Consultation Statement

North West Hatfield Supplementary Planning Document

Consultation Draft

Appendix B – Summary of representations to the draft SPD and the Council’s response

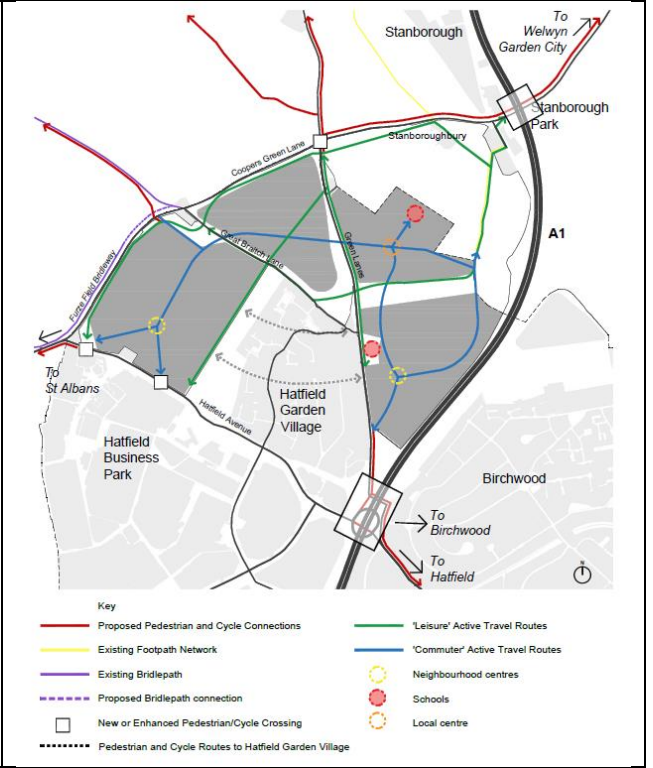
WelHat Cycling ID24	Pleased to see significant lengths of cycle route within the development. Support the plan to create a route separate from Coopers Green Lane. Support the plan to convert Green Lanes outside the primary school into a walking and cycling only school street.	Noted.	No changes required.
WelHat Cycling ID24	Concern about how cycle paths will link to the existing network through the Birchwood and Stanborough Junctions. Concern about indirect active travel links from Birchwood to the development employment zone and schools. Concern about the lack of cycle paths west towards St Albans.	Paragraph 5.2.12 notes the option of improving the existing active travel link at Airfield Roundabout to Birchwood. An additional arrow will be added to Figure 35: Active travel strategy plan to re-enforce this existing, and potentially to be improved, connection. Elsewhere cycling routes will be provided to connect to existing infrastructure around the site, noting that it is not	Amend Figure 35: Active travel strategy diagram by replacing the existing diagram with the following new plan:
